# **A joint statement from Blackpool, Walney and Warton Aerodromes on VHF radio communications**

## **Background**

## Annex A:

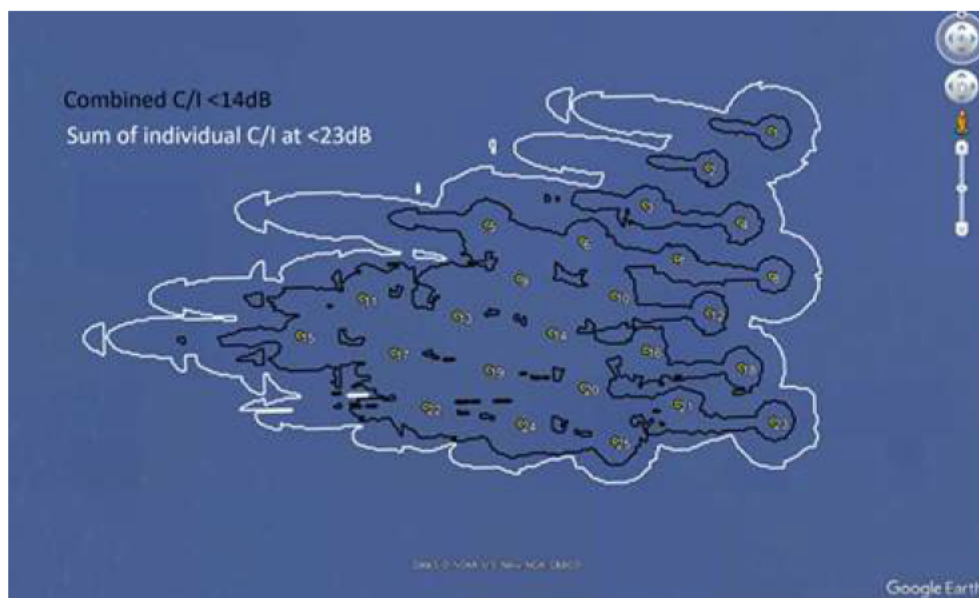
This however was not the only reason that I skipped over the combined turbine analysis in favour of treating each turbine as a stand-alone "worst single turbine interferer" at <23dB; It is the case for turbine as far apart as these that the individual impact dominates (see below the 500ft case and attached to show the trend gets more pronounced as altitude increases) and therefore it is erring on the side of caution when checking 169 turbines against 12 different radio stations to assume each turbine has their own volume of interference based on the worst case CAP670 criteria and select a few representative samples for analysis.

If Blackpool assume that radio performance will be sub-optimal within the volumes identified in the report (assuming that every turbine has a similar volume around it, which would merge at 500ft and 1000ft to encompass the complete farm, breaking down into pockets of interference at high altitudes)

they should hopefully be able to provide a statement as to how operationally significant this would be. If they can live with this worst case then we can put this to bed, if not we can look at some additional modelling for specific areas and radios before moving on to discuss mitigation.
